# Comparison of North American and Imported Crude Oil Lifecycle GHG Emissions

Stakeholder Input

July 22, 2009

## Stakeholder Input I. Stakeholder Workshop

The Mining+Upgrading pathway is depicted below:

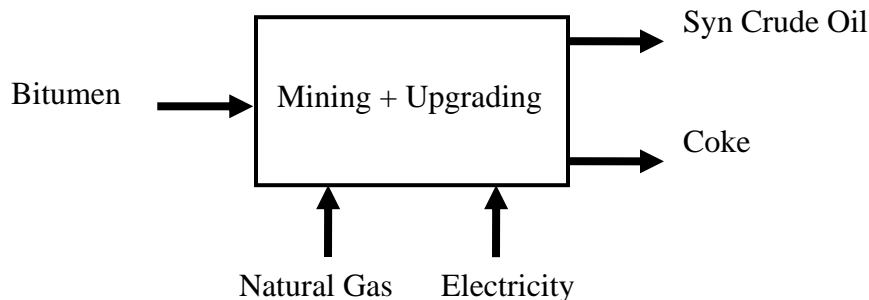
Oil sands mining/integrated coker upgraders in the Fort McMurray area could (and do) deliberately “sequester” their coke in the mines, and can in the long term include this in their land remediation. Should such operators be able to claim “Credit” for this deliberate act? If the coke is assumed to be burned in a powerplant, then is a credit granted for the mining, transport, and burning of coal?

The second pathway, mining+upgrading, does not consume any of the coke onsite, so we need to decide whether a portion of the recovery/upgrading energy and emissions should be allocated to it and if so, by what method. We recognize that other pathways are possible (e.g. Suncor utilizes a portion of their coke onsite and stockpiles the balance), however the pathway we are analyzing here does not use the coke onsite.

To determine how to split or allocate the recovery energy/emissions between the SCO and the coke, we need to consider the fate of the coke. There are two possible fates:

1. The coke is sold for use as a fuel (or stockpiled for future use as a fuel)
2. The coke is buried and considered sequestered
